2. Historic District Commission Meeting Packet 10-23-18

CITY OF YPSILANTI
Agenda
Historic District Commission
Tuesday, October 23, 2018 - 7:00 p.m.
City Hall, Council Chambers, 1 S. Huron
Ypsilanti, MI 48197

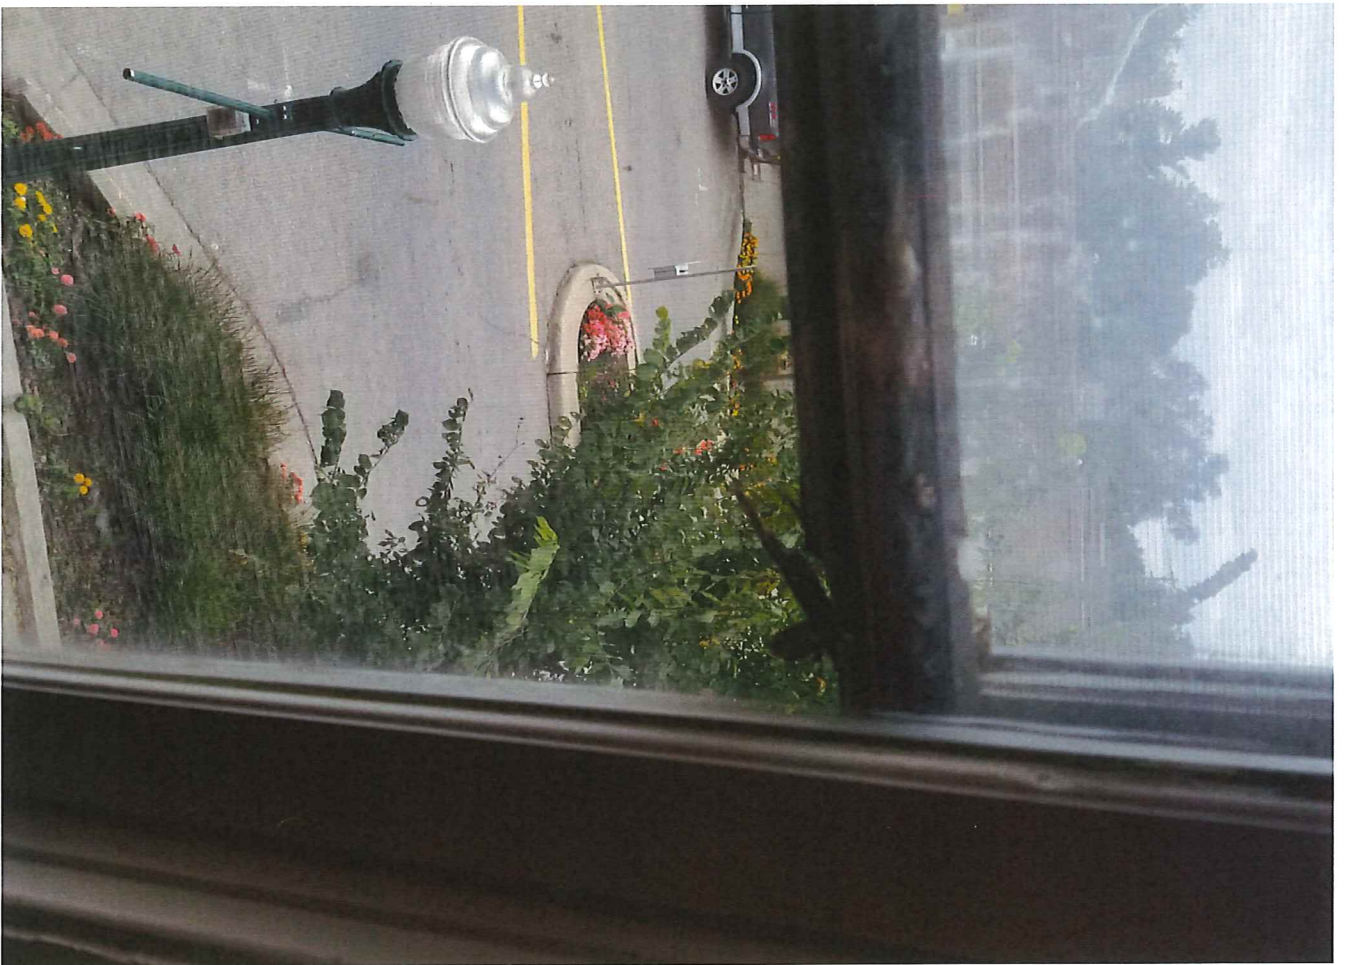
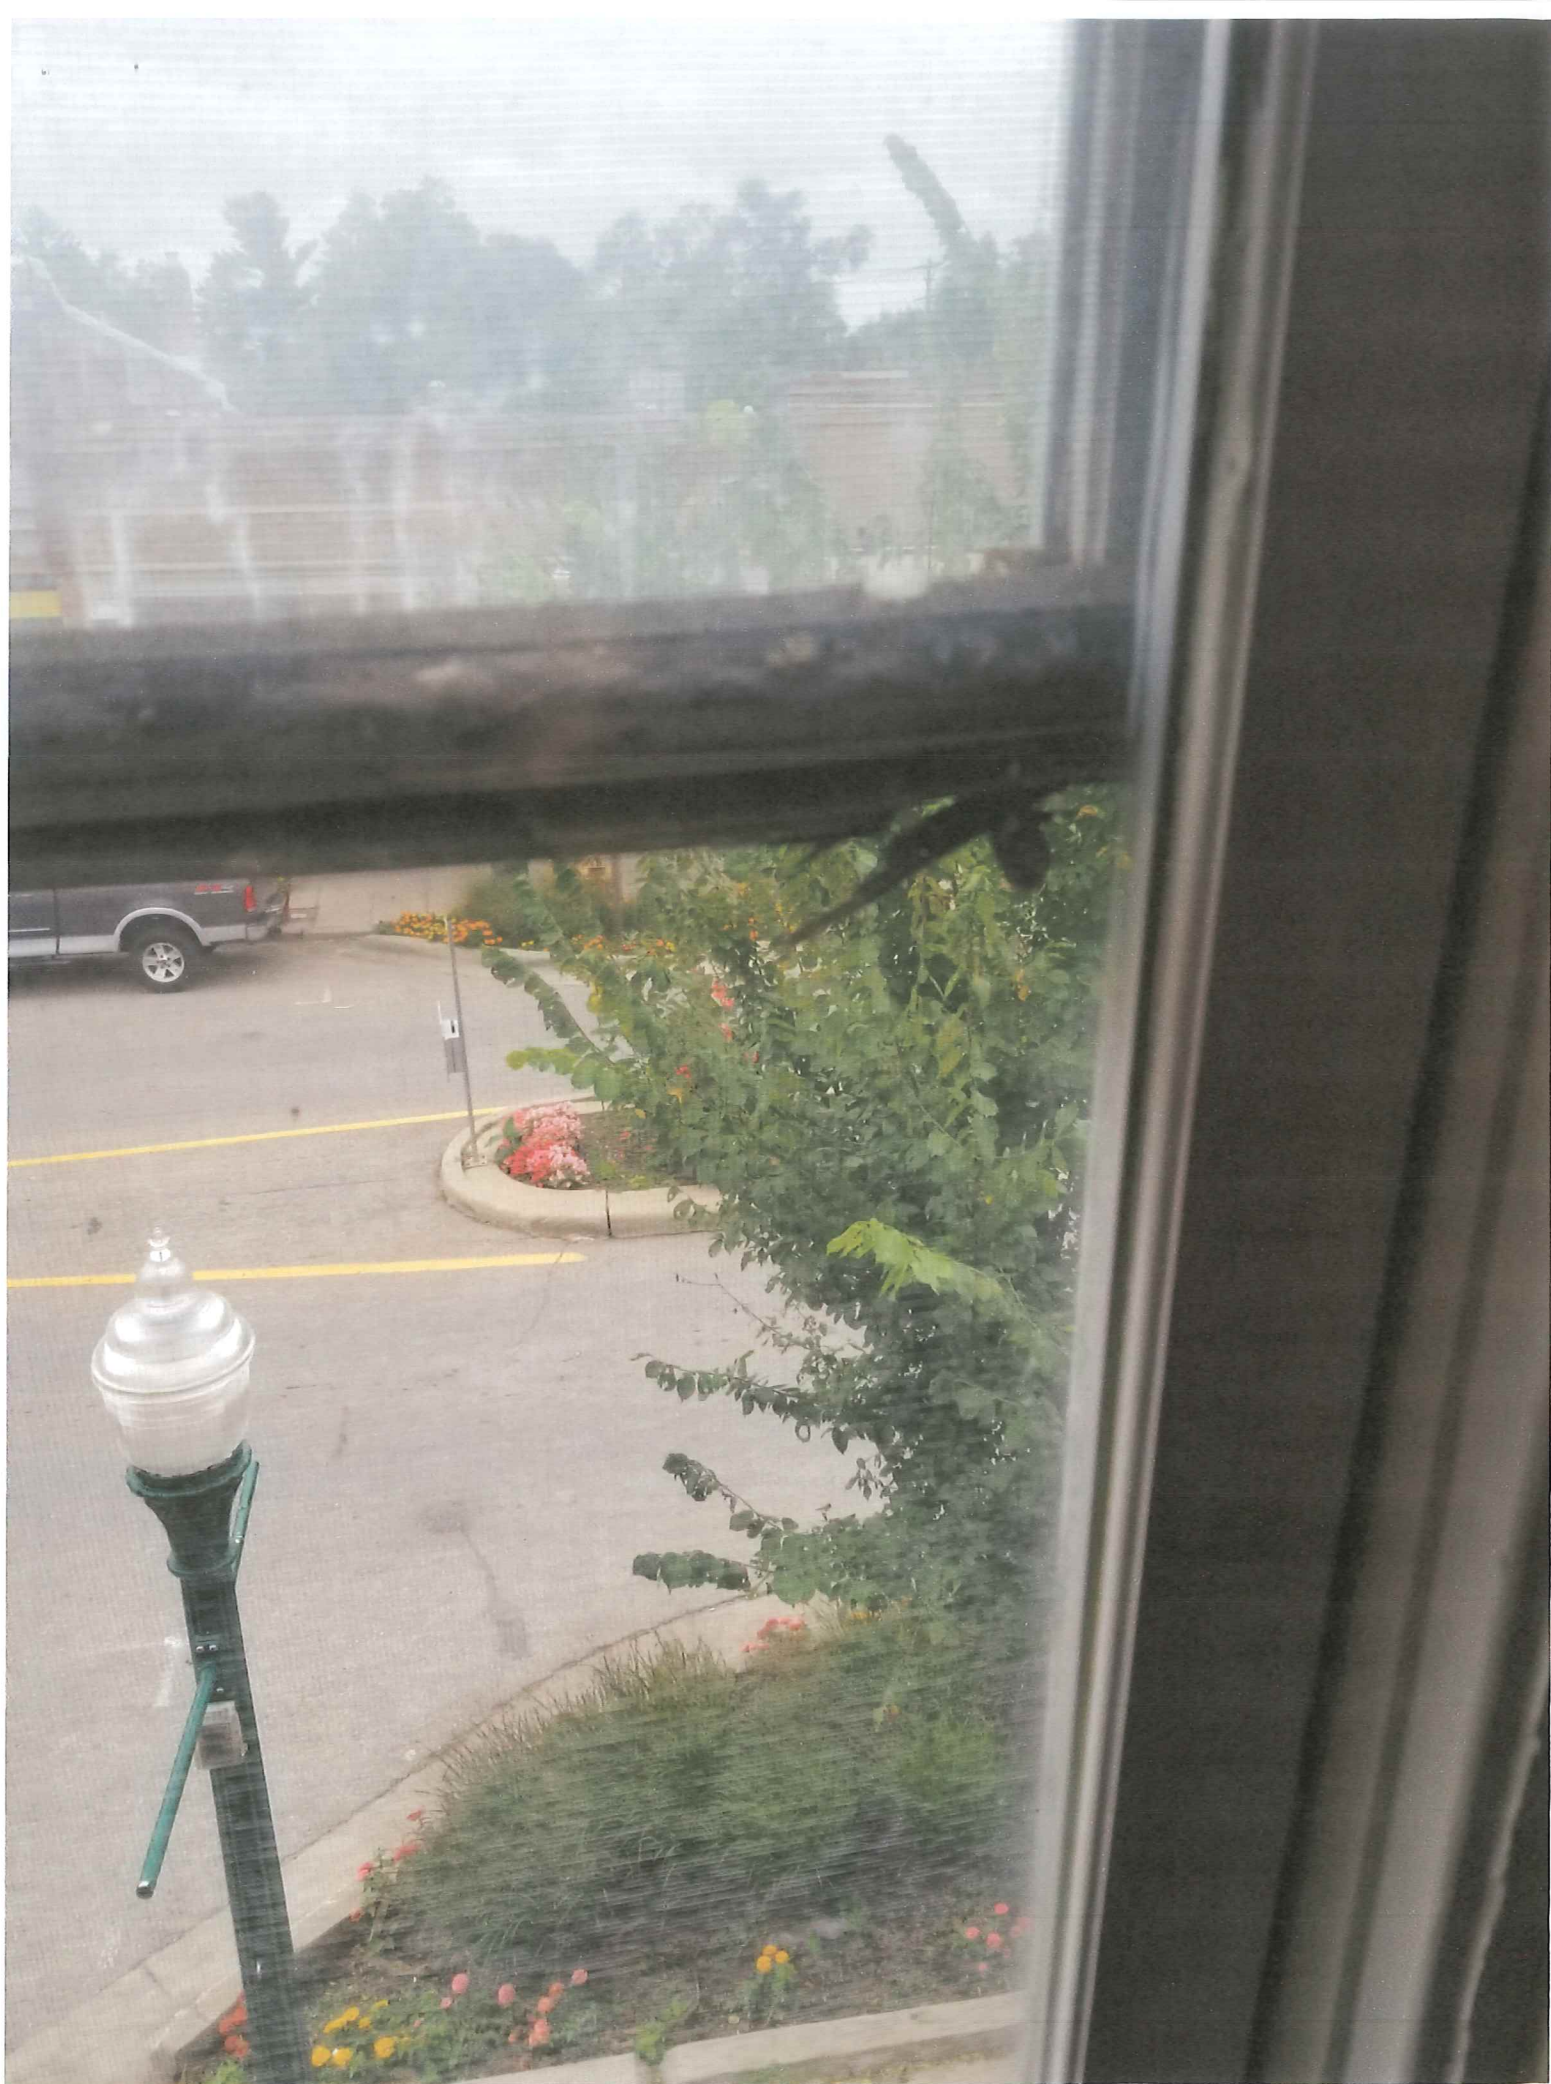
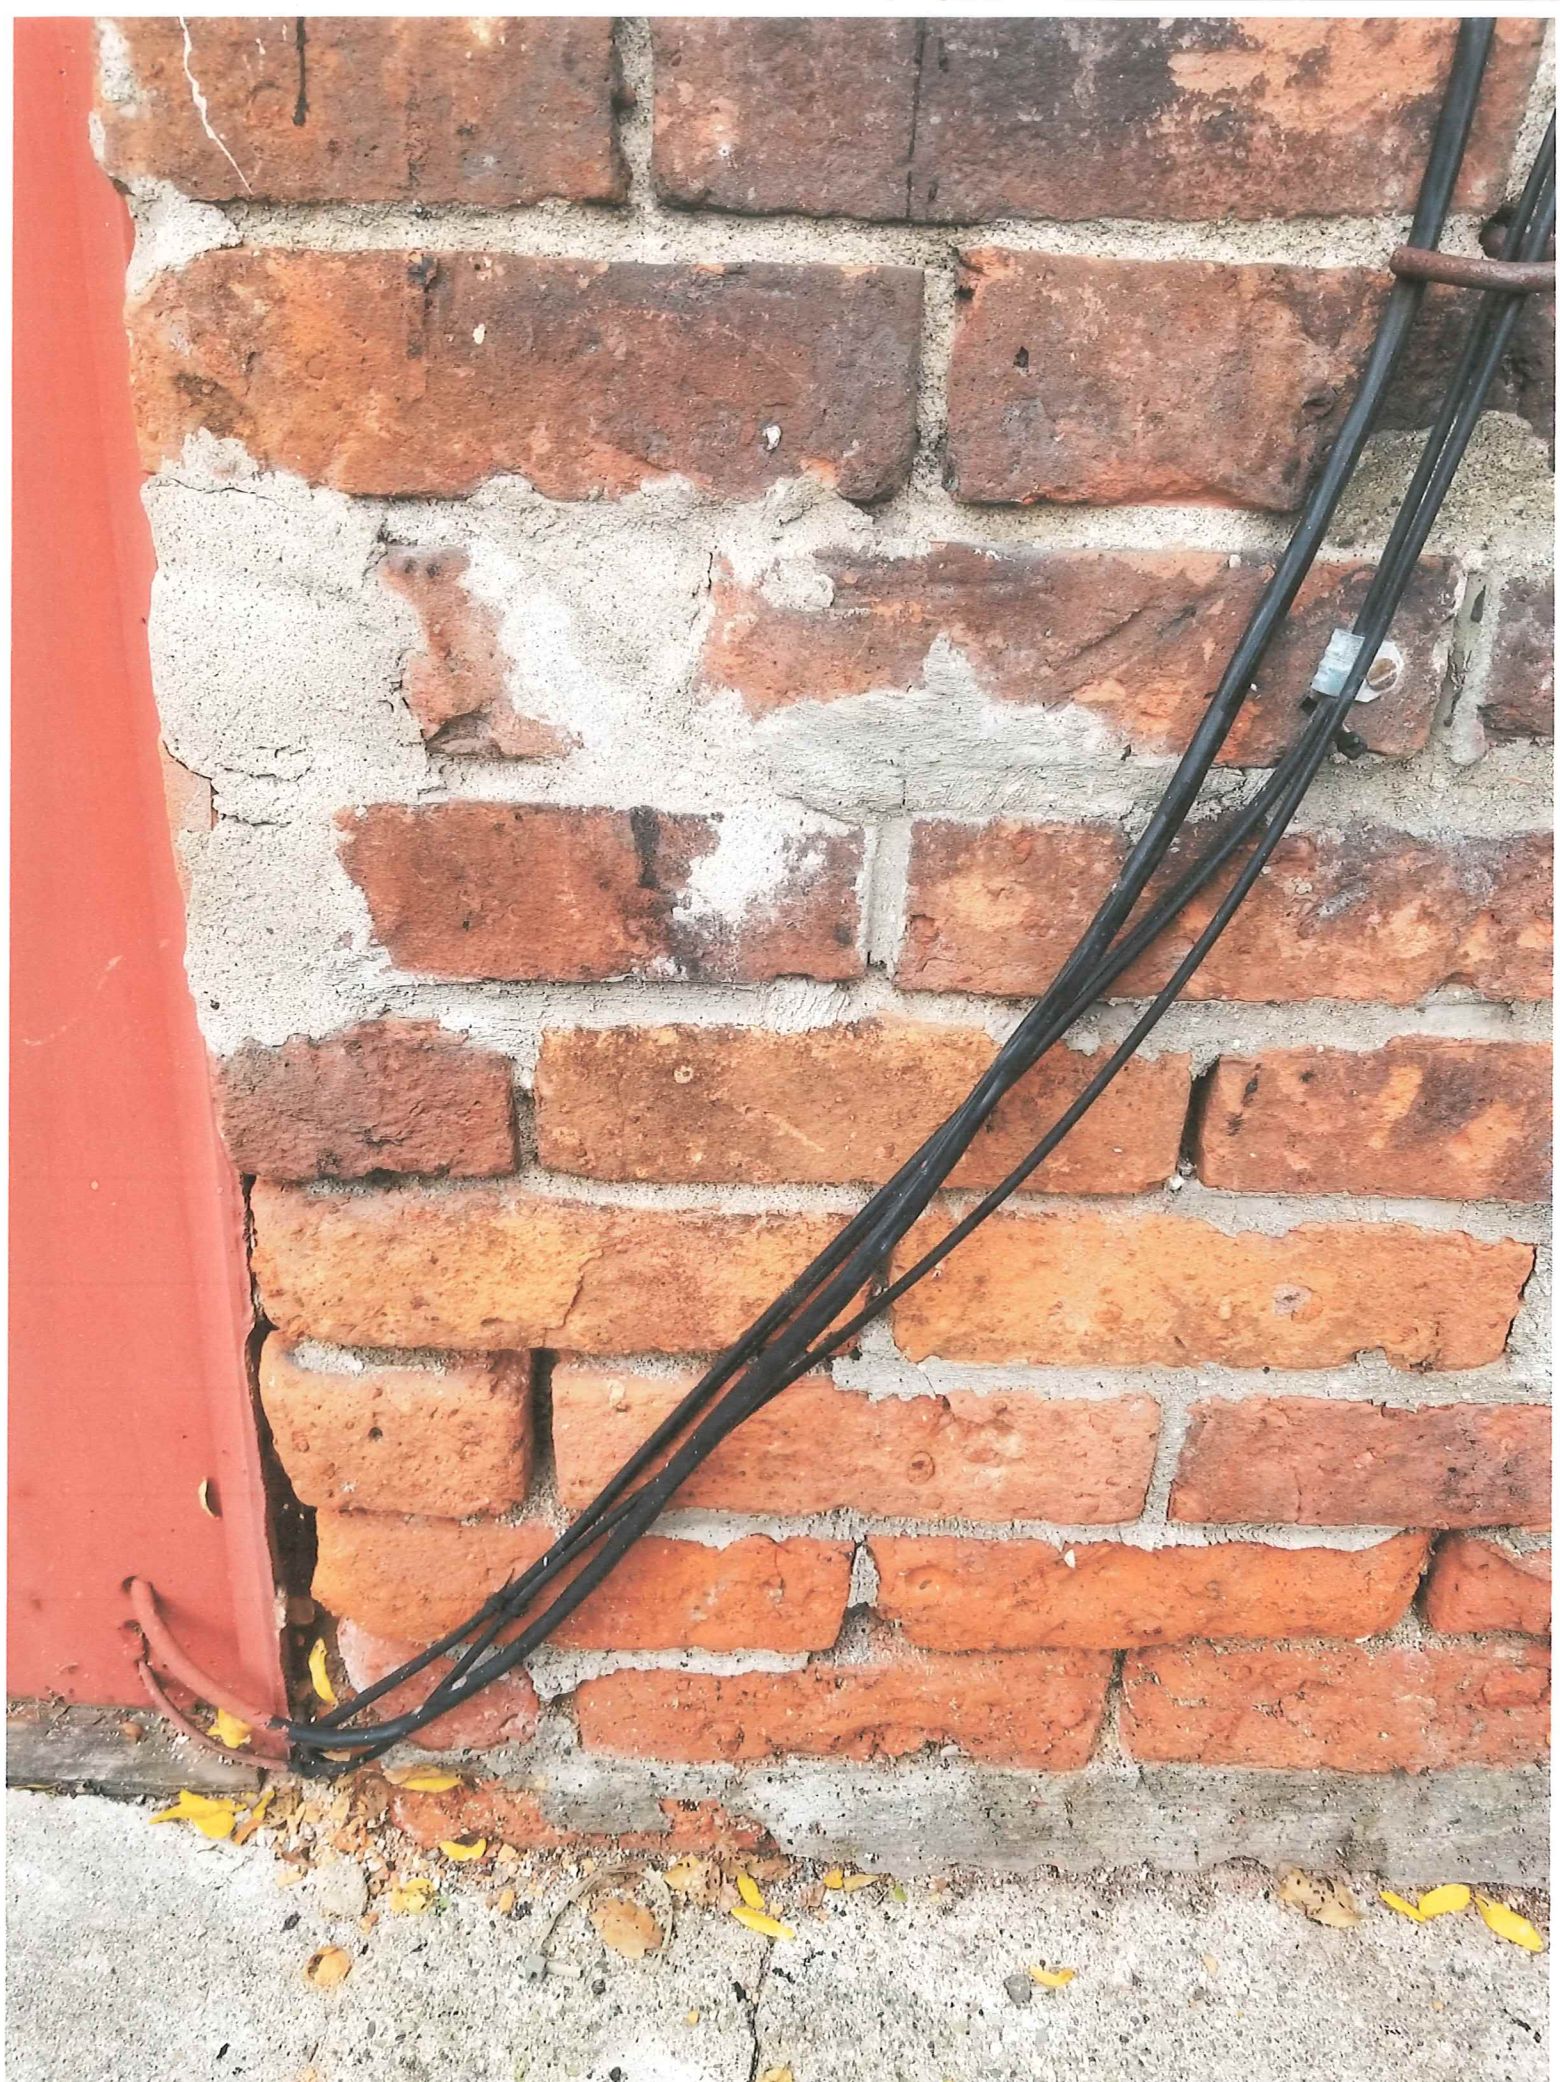
1. The applicant is applying to do tuck-pointing on the building as well as replace the seven windows on the 2nd story.
2. The applicant has proposed a Jeld-Wen aluminum clad wood replacement window with an arched top in the color Luxury champagne.
3. The applicant has not provided any details for the tuck-pointing. HDC to advise of the mortar mix as indicated in the HDC fact sheet or type O mortar mix.
4. A building department permit will be required and should be obtained prior to the start of work.

Move to approve and issue a certificate of appropriateness for work at 33-35 E Cross for the replacement of the seven upper story windows with Jeld-Wen 1-over-1 aluminum clad double hung arched top windows in Luxury Champagne exterior color with aluminum half screens. Work to also include tuck-pointing that meets the mortar mix requirements listed in the HDC masonry repair and cleaning fact sheet.
